Planning Applications Committee

9th February 2023

Modifications Sheet.

ITEM 5 - 19 ARRAS AVENUE, MORDEN, SM4 6DG

PROPOSED GROUND FLOOR PLAN

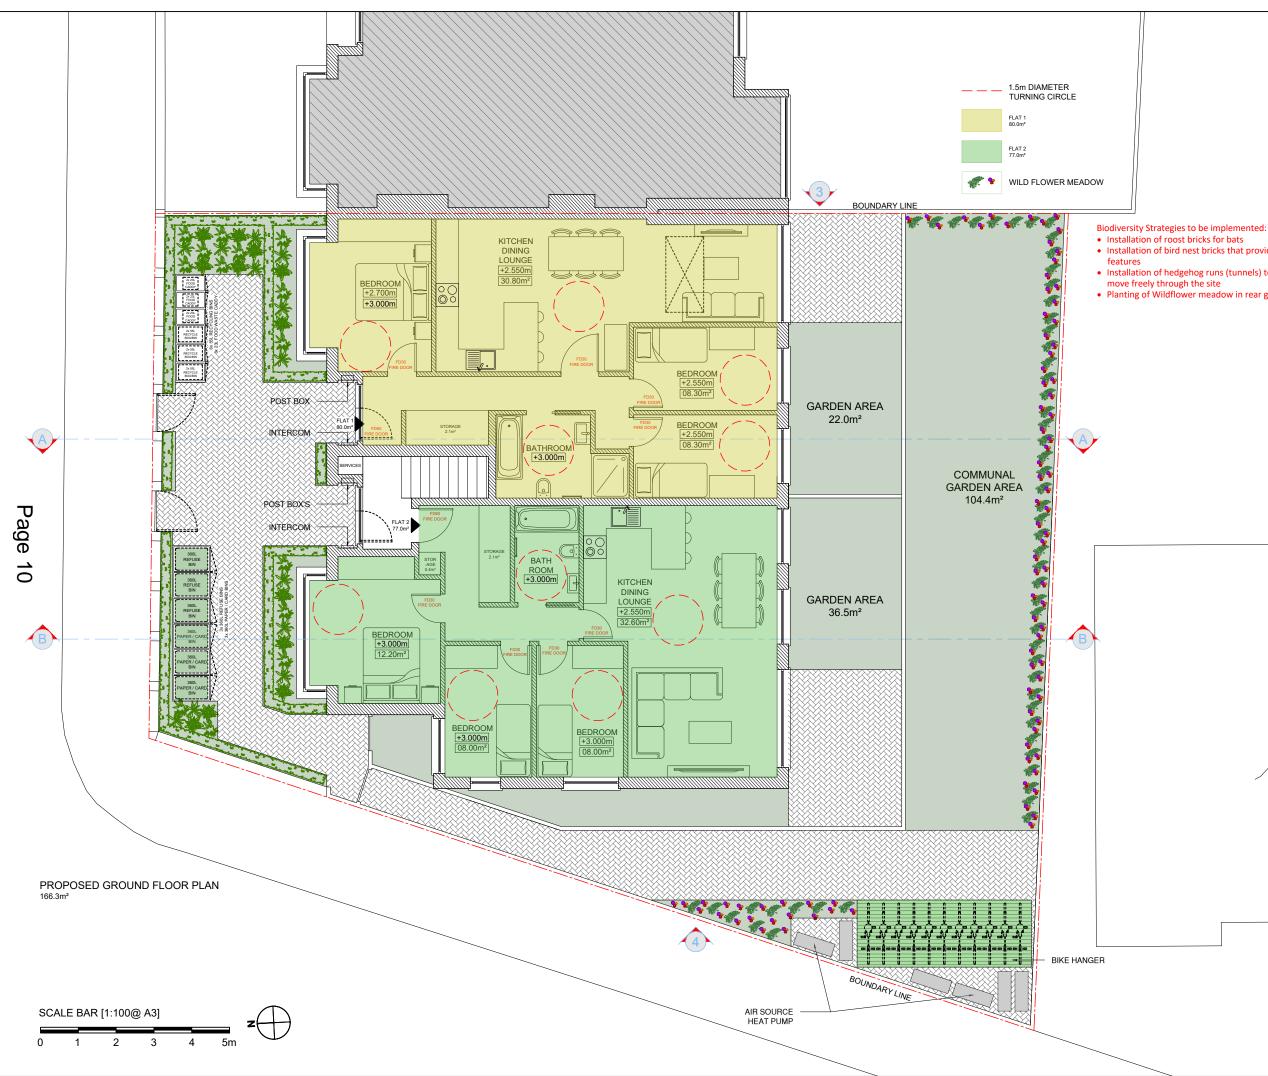
Following discussion with the applicant, amended drawings Rev B have been received (06.02.2023) showing biodiversity enhancements including;

- Installation of roost bricks for bats
- Installation of bird nest bricks that provide permanent nest features
- Installation of hedgehog runs (tunnels) to enable hedgehogs to move freely through the site
- Planting of Wildflower meadow in rear garden
- Inclusion of a green roof

• Installation of roost bricks for bats Installation of bird nest bricks that provide permanent nest

• Installation of hedgehog runs (tunnels) to enable hedgehogs to move freely through the sitePlanting of Wildflower meadow in rear garden

PROPOSED BIN STORE DETAIL

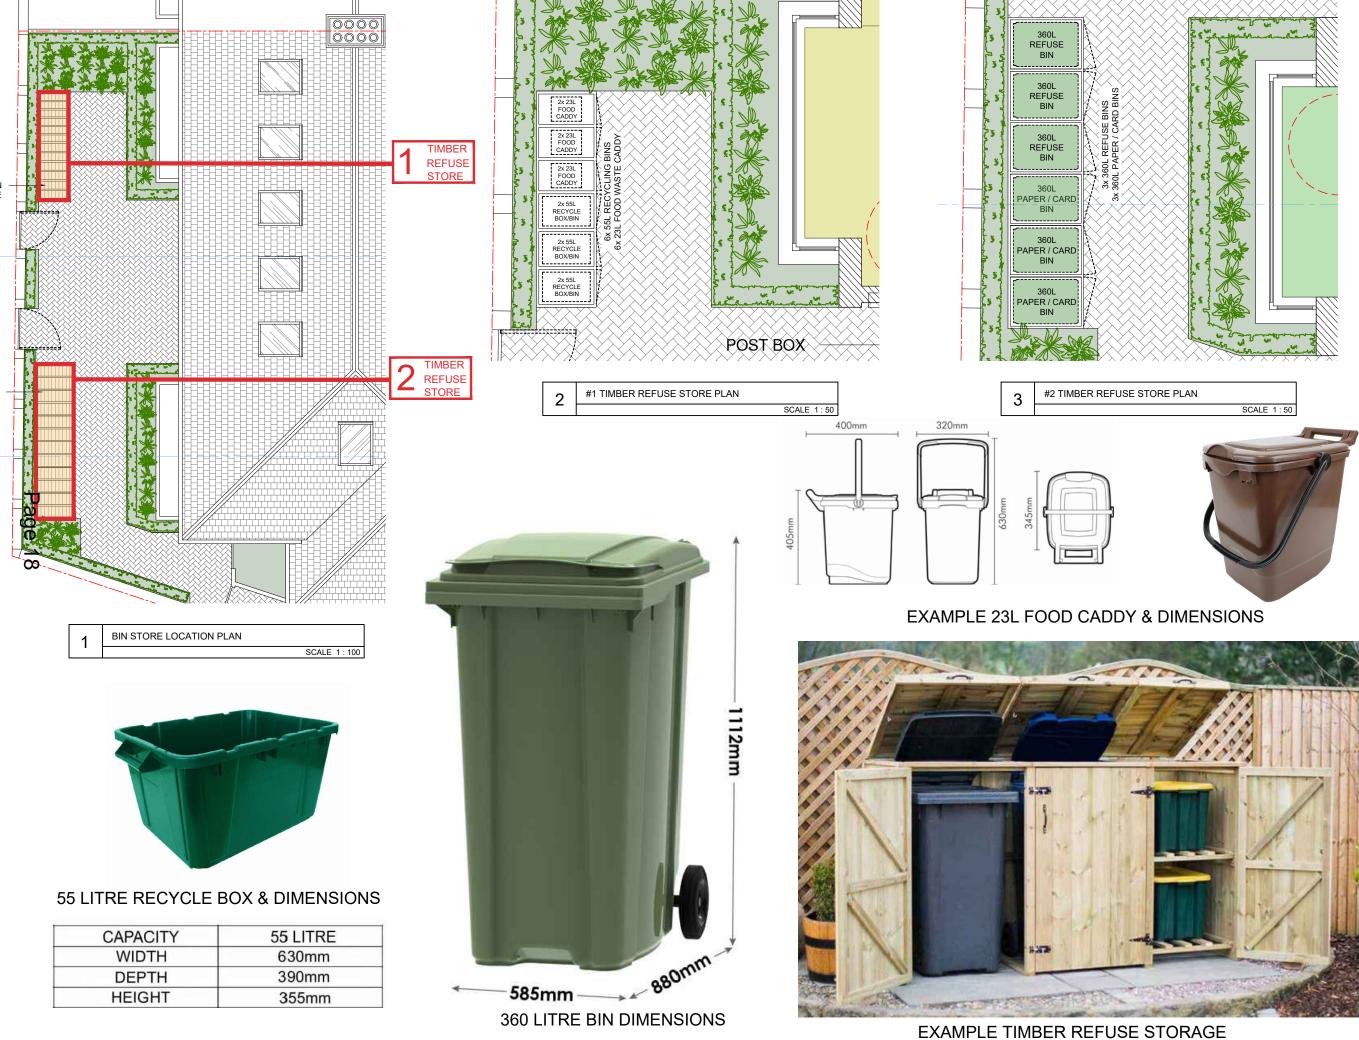
18 Rev B, 19 Rev B, 20 Rev B, 21 Rev B, 22 Rev B, 23 Rev B, 24 Rev B, 25 Rev B, 26' BIKE STORE PLAN' Rev B, 26 'TIMBER REFUSE STORE PLAN' Rev B
